U.S. Department of the Interior
BUREAU OF LAND MANAGEMENT

Well Name: SD WE 15 FED P9

Sundry ID: 2935885

Type of Action: Plug and Abandonment

Proposed WBD

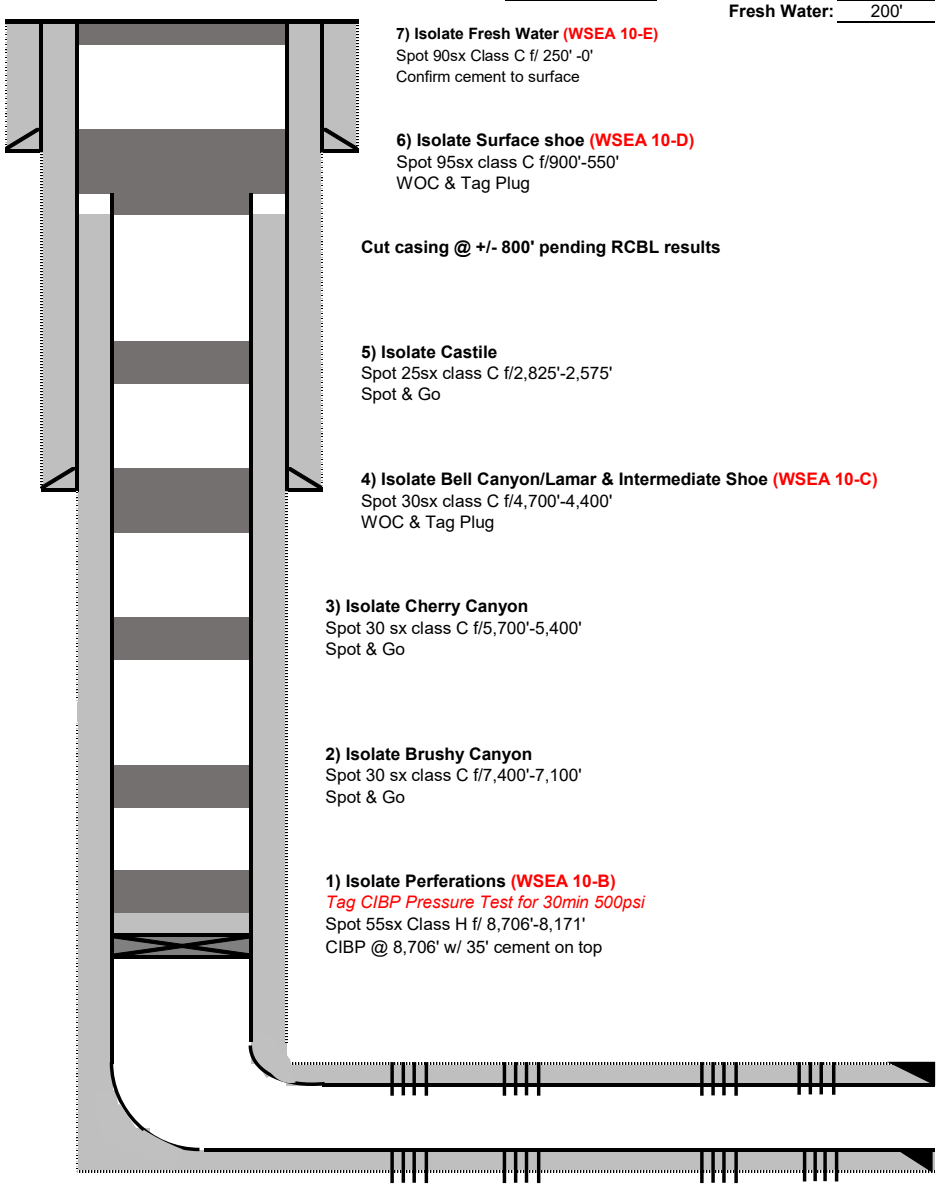
7) Isolate Fresh Water (WSEA 10-E)
Spot 90sx Class C f/ 250' -0'
Confirm cement to surface

6) Isolate Surface shoe (WSEA 10-D)
Spot 95sx class C f/900'-550'
WOC & Tag Plug

Cut casing @ +/- 800' pending RCBL results

5) Isolate Castile
Spot 25sx class C f/2,825'-2,575'
Spot & Go

4) Isolate Bell Canyon/Lamar & Intermediate Shoe (WSEA 10-C)
Spot 30sx class C f/4,700'-4,400'
WOC & Tag Plug

3) Isolate Cherry Canyon
Spot 30 sx class C f/5,700'-5,400'
Spot & Go

2) Isolate Brushy Canyon
Spot 30 sx class C f/7,400'-7,100'
Spot & Go

1) Isolate Perferations (WSEA 10-B)
Tag CIBP Pressure Test for 30min 500psi
Spot 55sx Class H f/ 8,706'-8,171'
CIBP @ 8,706' w/ 35' cement on top

PROPOSED P&A WELLBORE DIAGRAM - PRINT PAGE 2 OF 2 - HORIZONTAL

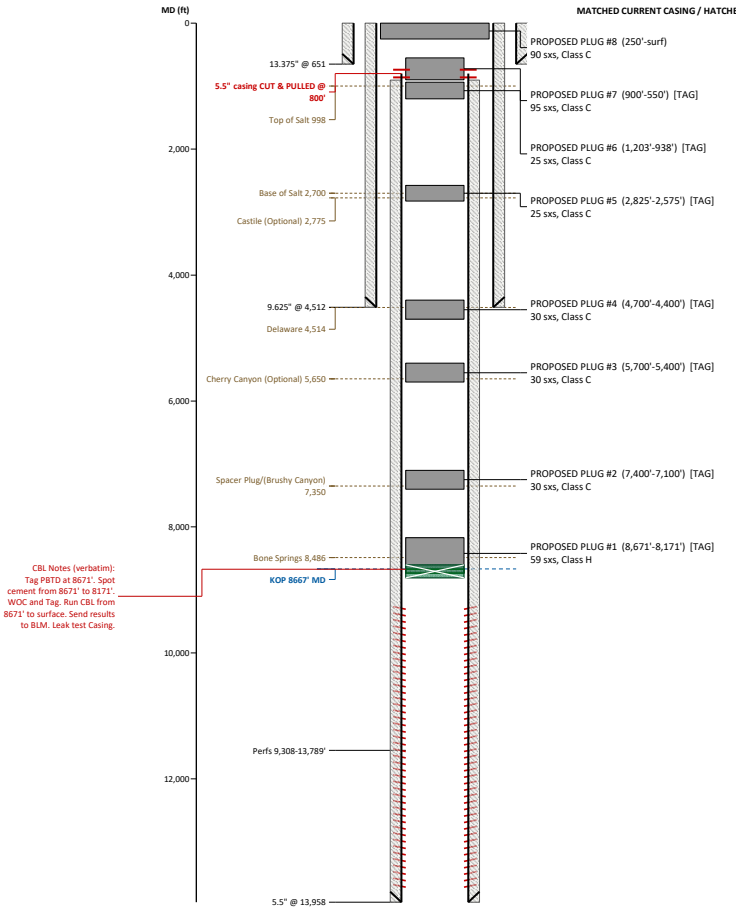
REVISED 3:53 PM, Oct 07, 2026

Operation	Depth / interval	Related
TAG instruction (see Notes)	550'	Plug #7
TAG instruction (see Notes)	938'	Plug #6
TAG instruction (see Notes)	2575'	Plug #5
TAG instruction (see Notes)	4400'	Plug #4
TAG instruction (see Notes)	5400'	Plug #3
TAG instruction (see Notes)	7100'	Plug #2
TAG instruction (see Notes)	8171'	Plug #1

CEMENT PLUGS (SHALLOWEST TO DEEPEST):
EXISTING PLUG 1: TOP 8671' / BOTTOM 8706' MD
Existing/set plug; quantity not entered
CIBPs (SHALLOWEST TO DEEPEST):
CURRENT / EXISTING CIBP @ 8,706'

Hole Size: 8.75"
Csg Size: 5.5" (ID 4.778")
Top of remaining casing: 800'
Set @: 13,958'
Cut & pulled @: 800'
Existing cement behind casing:
13,958' to 904'

1.00 Notify Regulatory Agency (BLM) a minimum of 24 hours prior to commencing work. MIRU well service unit and all necessary safety equipment.
2.00 ND WH, NU BOP. Test BOP per API and manufacturer recommendations.

3.00 PLUG #1: Tag PBTD at 8671'. Spot cement from 8671' to 8171'. WOC and Tag. Run CBL from 8671' to surface. Send CBL to BLM. Leak test Casing. (59 sxs, Class H)

4.00 Circulate plugging mud.
5.00 PLUG #2: Spot cement from 7400' to 7100'. WOC and Tag. (30 sxs, Class C)
6.00 PLUG #3: Spot cement from 5700' to 5400'. WOC and Tag. (30 sxs, Class C)

7.00 PLUG #4: Spot cement from 4700' to 4400'. WOC and Tag. (30 sxs, Class C)
8.00 PLUG #5: Spot cement from 2825' to 2575'. WOC and Tag. (25 sxs, Class C)

9.00 PLUG #6: Spot cement from 1203' to 938'. WOC and Tag. Conduct free point test. Cut and pull 5.5" casing at 800'. (25 sxs, Class C)
10.00 PLUG #7: Spot cement from 900' to 550'. WOC and Tag. (95 sxs, Class C)

11.00 PLUG #8: Spot cement from 250' to surface. (90 sxs, Class C)
12.00 REVIEW REQUIRED - CBL Notes were retained without rewriting. Confirm every explicit CBL start depth and the full CBL/RDMO sequence.
